UNITED STATES PATENT AND TRADEMARK OFFICE

Office Action Summary

10/663,653

KANIE, HIDEKI

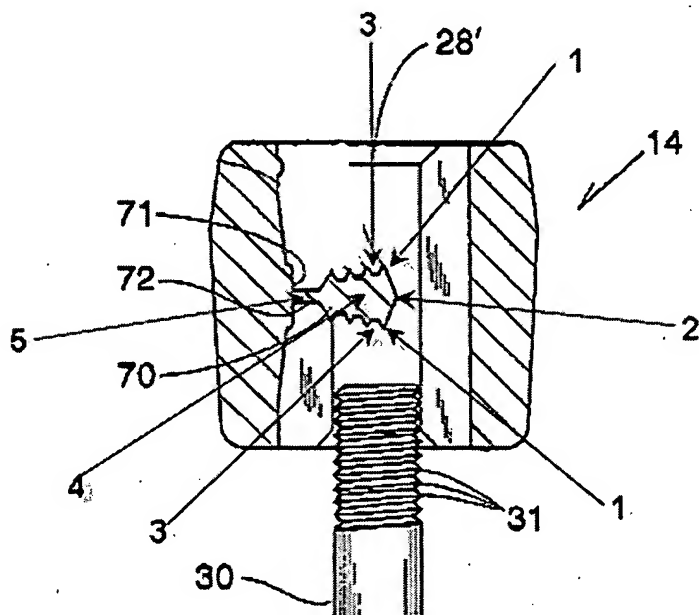
[3] Claims 1-13 are rejected under 35 U.S.C. 102(b) as clearly anticipated by Geiger, US-6,240,602, because the invention was patented or described in a printed publication in this or a foreign country, or in public use or on sale in this country more than one (1) year prior to the application for patent in the United States.

The shape and appearance of Geiger is identical in all material respects to that of the claimed design, *Hupp v. Siroflex of America Inc.*, 122 F.3d 1456, 43 USPQ2d 1887 (Fed. Cir. 1997).

As for Claim 1, Geiger teaches (Fig. 15) (also see figure below) of a device (14) to be attached to a threaded stud (30), comprising a body having a bore (28') for insertion of a stud (30), wherein the device (14) has only a single pawl (70), and, in the absence of a stud (31) in the bore (28'), the pawl (70) extends from an inner wall (71) of the bore (28') in a direction substantially perpendicular to a longitudinal axis of the bore (28'), wherein the pawl (70) has a flexible thin section (5) connected to the inner wall (71) and a thick section (4) extending from the thin section (5), wherein the pawl (70) can be bent in opposite directions at the thin section (5) for mounting the device (14) on a stud (30) from two directions, wherein only a single pair (1) of thread engaging sections are formed at opposite sides of the thick section (4) at a tip end (rightmost part) of the thick section (4), one or another of the engaging sections (1) being disposed for entering a space between crests of threads (31) of a stud (30) depending on a

direction of insertion of the stud (30) in the bore (28'), wherein only a single pair of grooves (3) are formed adjacent to corresponding engaging sections (1) of the pawl (70) at the opposite sides of the thick section (4), each groove (3) being disposed for receiving a crest of a thread (31) adjacent to the space between the crests, and wherein the opposite sides of the thick section (4) of the pawl (70) between the grooves (3) and the thin sections (5) are devoid of thread engaging sections and grooves corresponding to thread engaging sections.

As for Claim 3, Geiger teaches (Fig. 15) (also see figure above) of a device (14) to be attached to a threaded stud (30), comprising a body having a bore (28') for insertion of a stud (30), wherein the device (14) has only a single pawl (70), and, in the absence of a stud (31) in the bore (28'), the pawl (70) extends from an inner wall (71) of the bore (28') in a direction

substantially perpendicular to an axis of the bore (28'), wherein the pawl (70) has a flexible thin section (5) connected to the inner wall (71) and a thick section (4) extending from the thin section (5), wherein the pawl (70) can be bent in opposite directions at the thin section (5) for mounting the device (14) on a stud (30) from two directions, wherein a pair (1) of thread engaging sections are formed at an end (2) of the thick section (4), one or another of the engaging sections being disposed for entering a space between crests of threads (31) of a stud (30) depending on a direction of insertion of the stud (30) in the bore (28'), wherein a length of the thick section (4) of the pawl (70) is substantially greater than a distance between the inner wall (71) and a stud (30) fully inserted in the bore (28'), and wherein after full insertion of a stud (30) in the bore (28'), a centerline of the pawl (70) forms an angle substantially less than 90° from the centerline of the pawl (70) before insertion of a stud (30).

Re: Claim 4, wherein a tip of each engaging section (73) is arcuate in a plane perpendicular to the longitudinal axis of the bore (28') so as to conform to a curvature of the threads (31).

Re: Claim 5, wherein each groove (3) is arcuate in a plane perpendicular to the longitudinal axis of the bore (28') so as to conform to the curvature of the threads (31).

As for Claim 6, Geiger teaches (Fig. 15) (also see figure above) of a device (14) to be attached to a threaded stud (30), comprising a body having a bore (28') for insertion of a stud (30), and having only a single pawl (70) in the bore (28'), wherein the pawl (70) is connected by a hinge (5) to a first inner wall (72) of the bore (28'), wherein the pawl (70) has a centerline extending in a first direction substantially perpendicular to an axis of the bore (28') before insertion of a stud (30) in the bore (28') and forming an angle of substantially less than 90° with

respect to the first direction after full insertion of the stud (30) in the bore (28'), and wherein the pawl (70) has only a single thread engaging section (1) at a pawl tip at one side of the pawl, that enters a space between successive crests of threads (31) of a stud (30) and has only a single adjacent groove (3) at said one side of the pawl, that receives one of the crests of the thread (31), wherein the pawl (70) has a length (via 4) along said one side between the groove (3) and the hinge (5) that is devoid of thread engaging sections and thread crest receiving grooves, and wherein a second inner wall (inside 22) of the bore (28') is constructed to minimize lateral movement of the stud (30) in the first direction, and in a direction orthogonal to the first direction.

Re: Claim 7, wherein the second inner wall (inside 22) of the bore (28') is dimensioned to closely surround a major portion of the circumference of the stud (30).

Re: Claim 8, wherein the engaging section (1) and the groove (3) are formed on a section of the pawl (70) substantially thicker (4) than a section of the pawl (70) forming the hinge (5).

Re: Claim 9, wherein there is only a single engaging section (1) and only a single groove (3) at each of opposite sides of the thicker section of the pawl, whereby an engaging section (1) and a groove (3) can engage threads (31) of the stud (30) irrespective of the direction of insertion of a stud (30) into the bore (28').

Re: Claim 10, wherein tips of the engaging sections (1) and the grooves (3) are arcuate in a plane perpendicular to the longitudinal axis of the bore (28') to conform to the curvature of the threads (31) of the stud (30).

Re: Claim 11, wherein a stud (30) is disposed in the bore (28').

Re: Claim 12, wherein the body includes a component mounting section for holding a component (Fig. 14).

Re: Claim 13, wherein the body includes a component mounting section for holding a component (Fig. 14).

[4] Applicant's arguments filed 11/21/2006 regarding rejections under 35 U.S.C. 102 have been fully considered but they are not persuasive. Examiner maintains that the amended subject matter presented by applicant in the instant amendment is still anticipated by the prior art of Geiger. A figure has been provided (see above) to help show that the structure of Geiger does indeed anticipate that of the claims. It is the claims that define the claimed invention, and it is claims, not specifications that are anticipated or unpatentable. *Constant v. Advanced Micro-Devices Inc.*, 7 USPQ2d 1064. Applicant states that Geiger does not teach of only a single pair of thread engaging sections formed at opposite sides of the thick section at a tip end of the thick section and a single pair of grooves formed adjacent to corresponding engaging sections. The examiner disagrees. Though the applicant amended the claim to include that only a single pair of thread engaging sections are formed, said pair was limited to be formed at opposite sides of the thick section at a tip end of the thick section. As shown from the figure provided above, Geiger does indeed show a only a single pair (1) of engaging sections and grooves (3) found on opposite sides of the thick section and at the tip end (to the rightmost part) of said section. Though Geiger may show other thread engaging sections, said sections are not found at a tip end of the thick section.
